AGENDA  
HISTORIC PRESERVATION / DESIGN REVIEW COMMISSION

August 3, 2016 – 4:30 PM

REPORT OF THE HISTORIC PRESERVATION / DESIGN REVIEW COMMISSION

**Parking Area  
Design Review Request  
1408-10 College Avenue  
July 27, 2016**

Second floor window with brick veneer separation at sill and jambs.

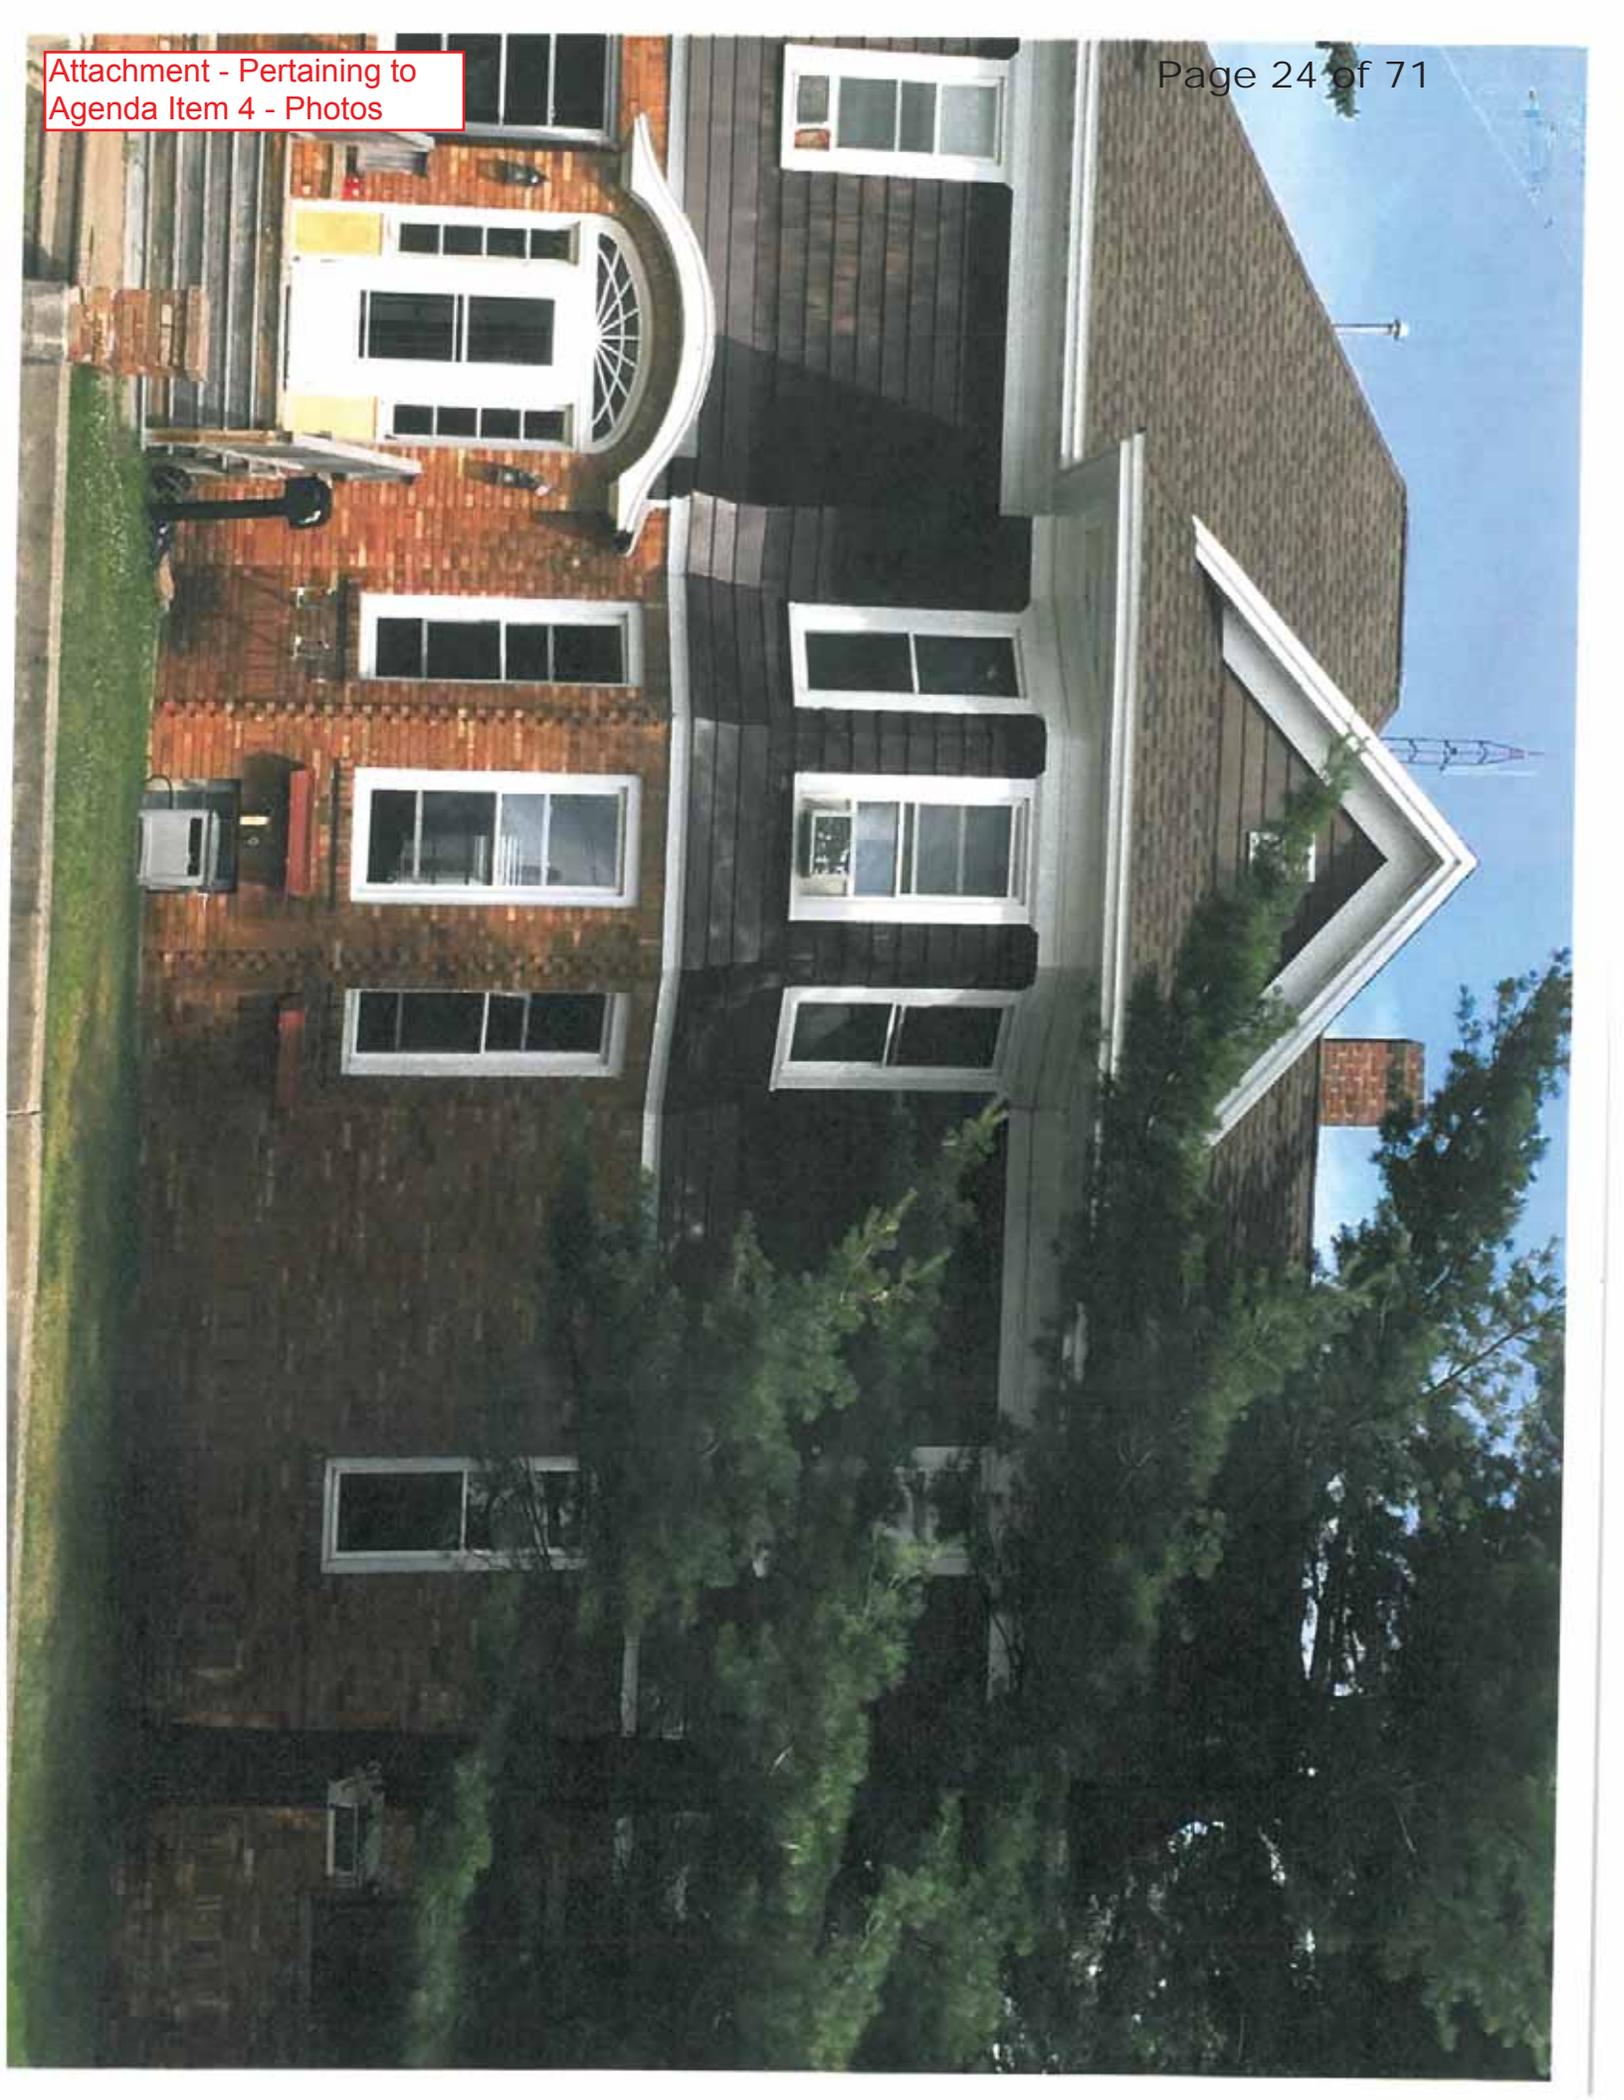
Second floor windows with brick veneer separation.

Wood exterior wall with corroded metal tie not engaged with brick veneer.

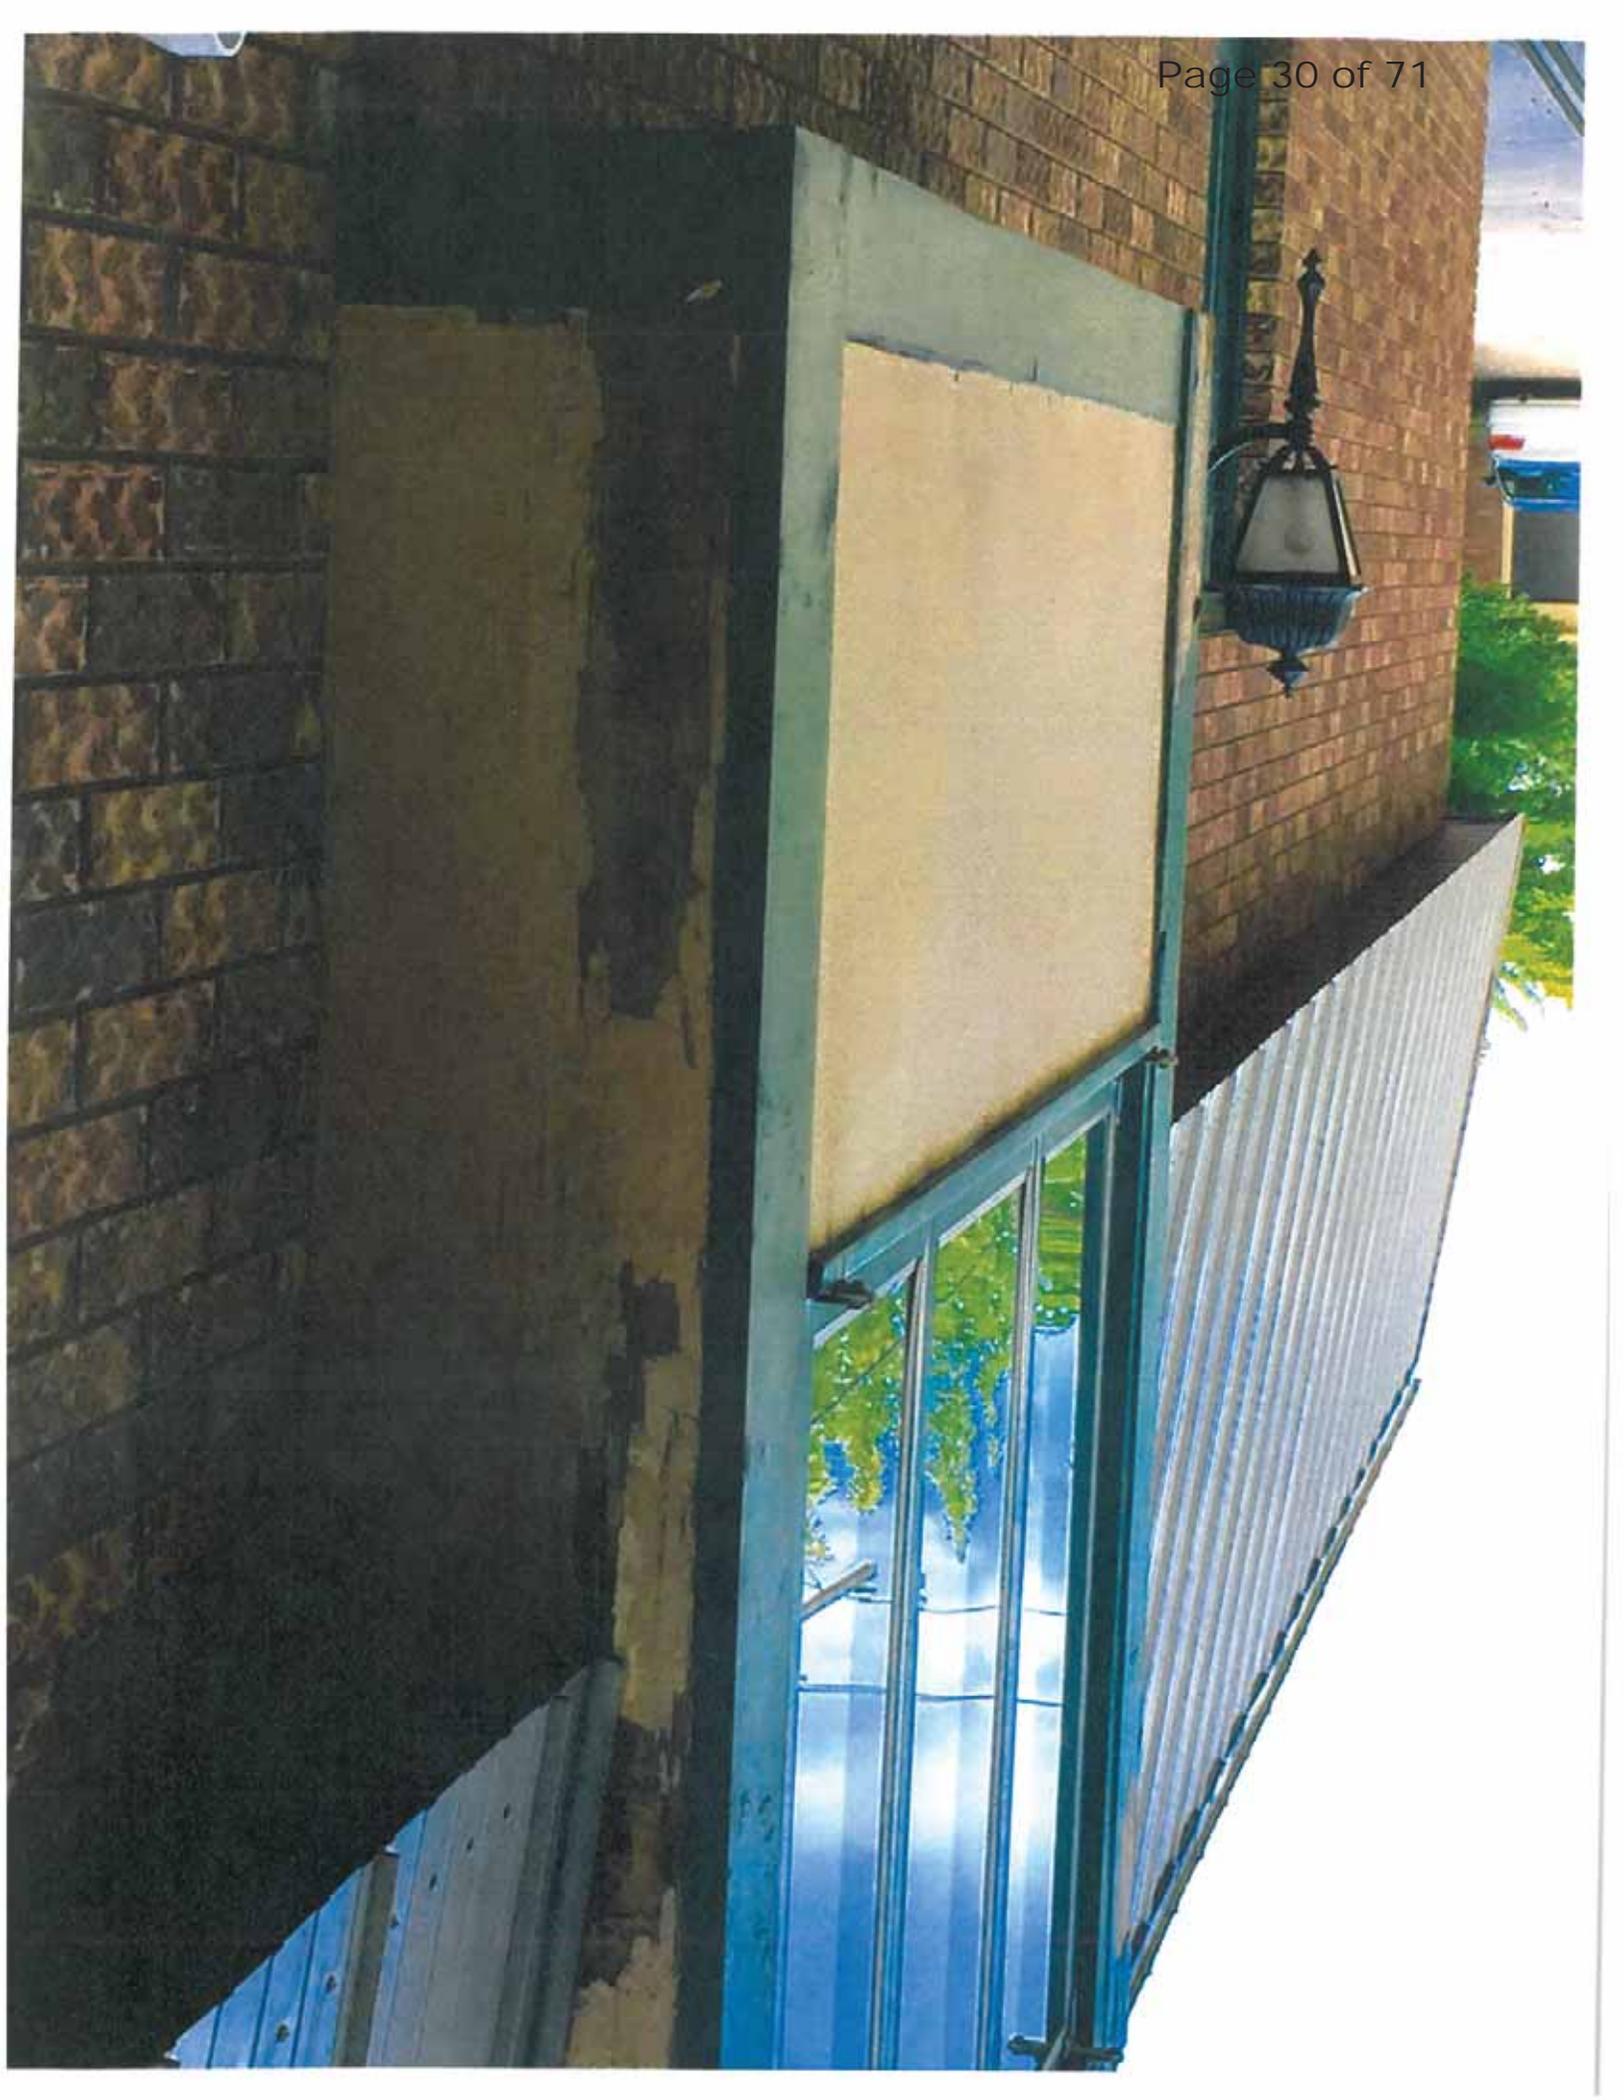
- d. Horizontal metal tabs were observed to be fastened to the wood wall system, but those that could be observed were not engaged with the brick veneer. It is expected that these tabs remain from the original system of ties that were embedded in the brick mortar joints and served to provide horizontal support for the veneer.

- e. The metal tabs that could be observed exhibited signs of severe corrosion.
- f. No horizontal brick ledger element along the length of the wall and near the second floor elevation was observed as would be expected in typical multi-story brick veneer construction. This feature is normally included, even in historic structures, to provide vertical and lateral support for the brick and allow for movements of the veneer system due to temperature and moisture fluctuations.

ROUGH DRAFT OF PARKING PLAN

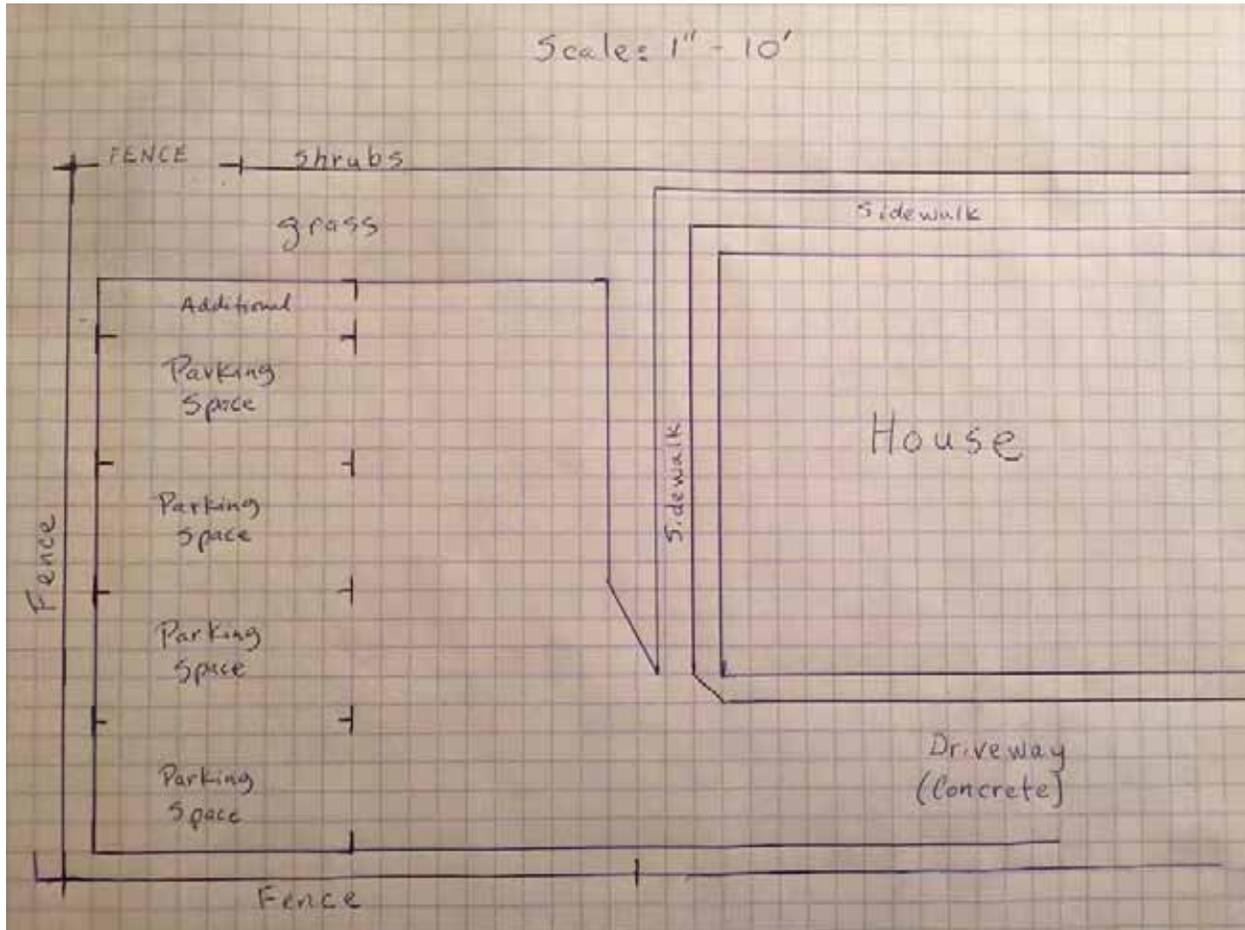
**Analysis:** Parking stall widths, complete landscaping, construction materials, and other requirements have not been identified on the plan.

**Analysis:** The parking area is proposed east of the existing concrete driveway.

**Findings:** Staff would recommend that all pertinent ordinance requirements be met. An updated parking plan shall be submitted for review and approval by Community Development Department.

**Findings:** Staff would recommend the parking area be concrete to match the existing driveway.
